City of
Richmond

Report to Development Permit Panel

File: DP 11-566011

Re: Application by Omicron Architectural Engineering Construction Ltd. for a
General Compliance Ruling at 15111 Williams Road and Richmond Key 195105

- Figure 1 – "Triangle Lot" Habitat Plan, March 2016 & November 2017
- March 2016 and November 2017 Richmond Industrial Centre Habitat Balance Sheets

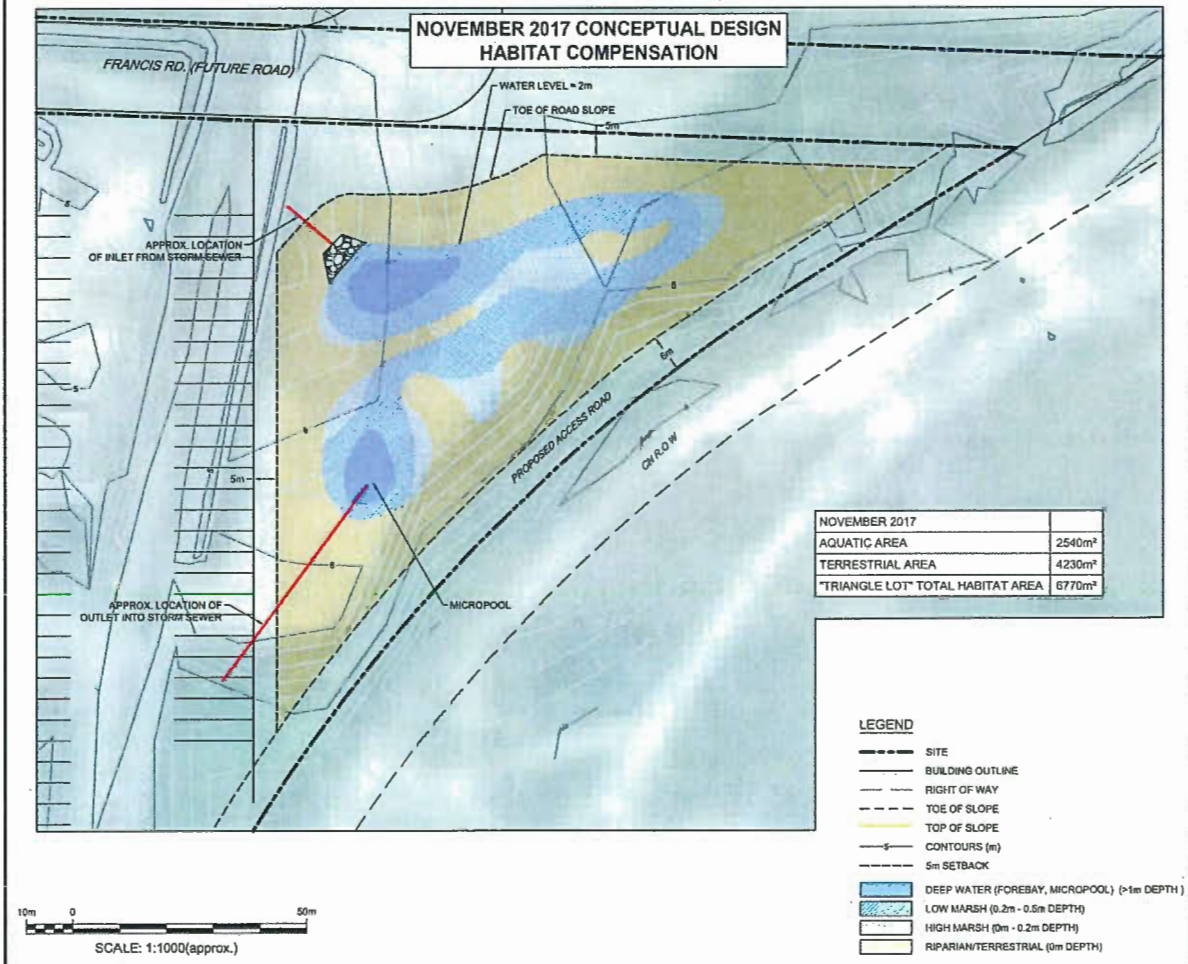
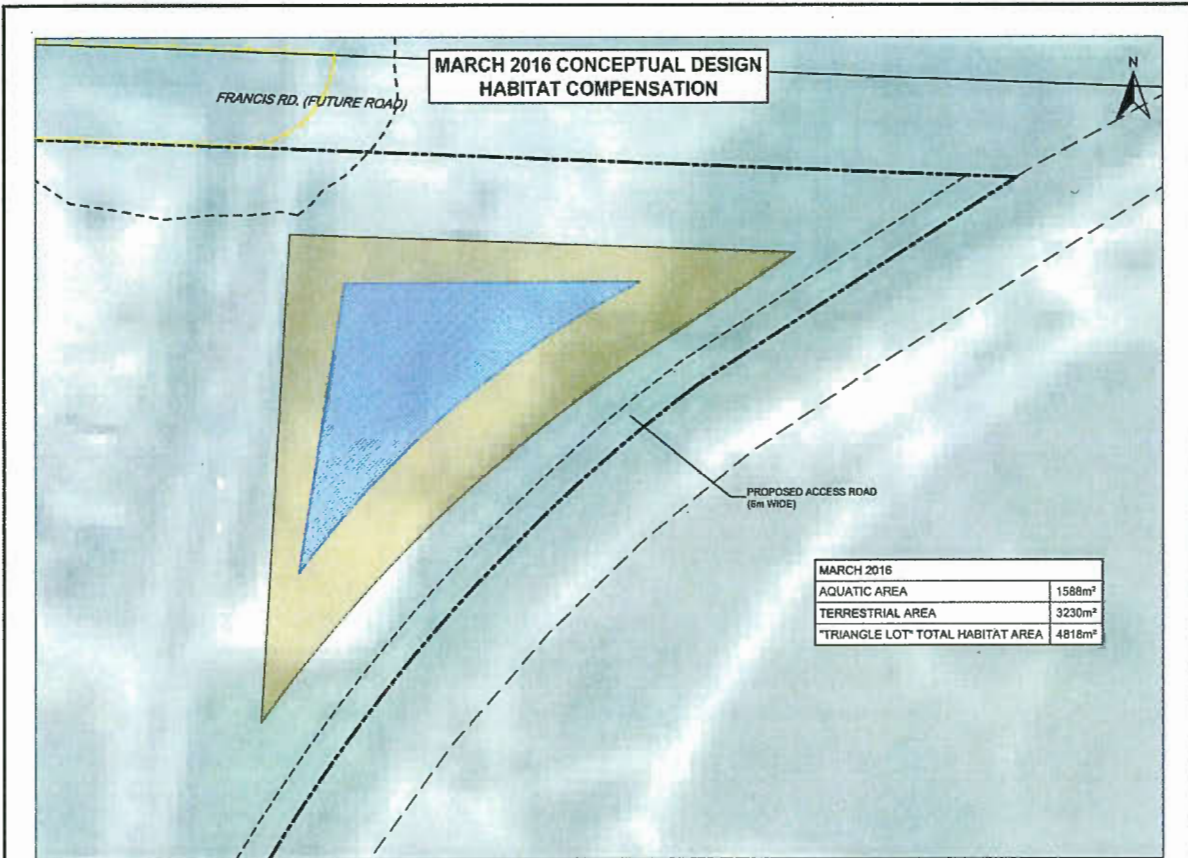
Since May 2016, recent changes to the proposed design of the development (straightening of the proposed Grayson/Pierson Road alignment) have resulted in reducing the area available in the “Triangle Lot” for the proposed compensation wetland. This letter re-evaluates the wetland feasibility based on the new design constraints.

The proposed road realignment will require changing the design slope of the wetland to 3 (H) to 1 (V), the previous design allowed for a 4 (H) to 1 (V) design slope. The proposed riparian planting plan for the wetland will be revised to include plant species suitable for the increased slope. Tree species, including western redcedar (*Thuja plicata*) and Sitka spruce (*Picea sitchensis*), originally proposed for the sloped areas on the north and west sides of the wetland is planned to be replaced with Pacific willow (*Salix lucida* ssp. *lasiandra*) and hooker’s willow (*Salix hookeriana*), which are more suitable for slopes that may become seasonally inundated. This does not preclude planting of larger coniferous trees, such as cedar or spruce outside sloped areas. Additional trees is planned to be included on the flatter riparian area on the southeast side of the wetland. A detailed revised planting plan will be submitted to the City of Richmond for approval.

The following table presents a comparison of the aquatic and terrestrial riparian compensation areas for the “Triangle Lot” wetland areas presented in the March 2016 habitat balance with areas in the November 2017 redesign based on the proposed road realignment.

Habitat Type	March 2016 Wetland Design (m ²)	November 2017 Wetland Design (m ²)	Area Difference (m ²)	% Difference
Aquatic Area	1,588	2,540	+952	+60%
Terrestrial Riparian Area	3,230	4,230	+1,000	+31%
Total “Triangle Lot” Habitat Area	4,818	6,770	+1,952	+41%

The proposed realignment of Graymont/Pierson Road is feasible from a habitat compensation perspective, and is considered to maintain the functioning wetland habitat and achieve a net habitat balance as required by the City of Richmond. The proposed realignment will result in a slight (approximately 30 m²) encroachment into the "Triangle Lot." However, the total habitat areas available for the compensation wetland is being increased by 1,952 m² (when compared to March 2016 values), resulting in an overall net increase in both aquatic and riparian areas. It is understood the "Triangle Lot" wetland is planned to undergo detailed design and planting plan revisions to accommodate the new road footprint, and potential design responses to data collected from the Wetland Hydrogeological Assessment (currently in progress).
